**NC Department of Insurance  
Office of the State Fire Marshal - Engineering Division  
1202 Mail Service Center, Raleigh, NC 27699-1202  
919-661-5880**

Barrier Height Requirements for Sloped Ceilings Under Stairways

**Code:** 2012 Building Code  
**Section:** 1003.3 and 1101.2

**Date:** July 1, 2015

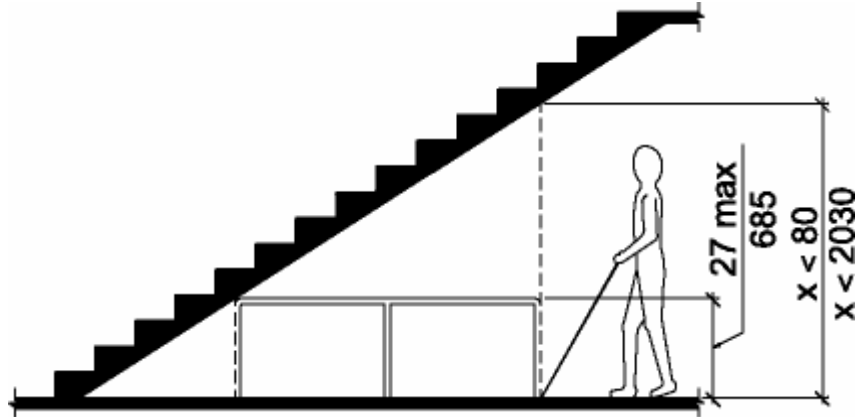
For condition such as shown in the photo below, is there a minimum height for the rail providing the vertical clearance beneath the stair that is required in ANSI A117.1, Section 307.4?

No, there is not. While the North Carolina Building Code 1101.2 references that buildings and facilities shall be designed to be accessible in accordance with the NCBC and ANSI A117.1, Section 307.4 states only that the leading edge of such a rail or barrier providing the vertical clearance shall be located 27 inches maximum above the floor. The standard is silent on what the minimum height of the rail or barrier shall be.

The intent of the vertical barrier is to allow detection of an overhead obstruction at the floor level by someone with a visual impairment before that person bumps into the overhead protrusion. The guard, rail or other type of barrier shall be installed so that it can be detected, typically, by a cane, as indicated in ANSI A117.1, Figure 307.4 (below). The cane will locate the barrier, allowing the person to turn away from the overhead obstruction.

A low height barrier is not as effective as a higher barrier. A person with a visual impairment may mistake a low curb for a step or stair tread, step up onto it, hitting the person's head. A higher rail at handrail height may not be detectable by a cane before the person using it walks into the rail. Consider also that children and persons of shorter stature may have a detectable range below 27 inches.

While there are no minimum height requirements in ANSI A117.1, Section 307.4, there have been requests for recommendations as to a minimum height. The designer may wish to look toward similar locations in ANSI to see what dimensions have been used so that the guard or rail would not be considered a ‘tripping hazard’. For non-visually impaired individuals, this should not be an issue, however, there is a new and growing group of what has become termed as ‘wi-fi challenged’ individuals who tend to focus on hand-held devices rather than where they are walking. In this arena, designers may believe that it is legally prudent to select a reasonable minimum barrier that is related to other relevant ANSI standard sections

Where a curb is required on the edge on a ramp, in line with the handrails/guardrails, ANSI 405.9.2.1 requires a 4” minimum curb for edge protection. The 4” height is intended to prevent chairs of a wheelchair from slipping off, a crutch tip from getting to the edge of the ramp or landing, or to maintain a similar restriction for the leg of a walker. The same 4” height may work as a minimum height, since the code is silent on what the minimum height of the guardrail or barrier shall be. Remember, though that the 4” curb is provided along with the handrail, not by itself.
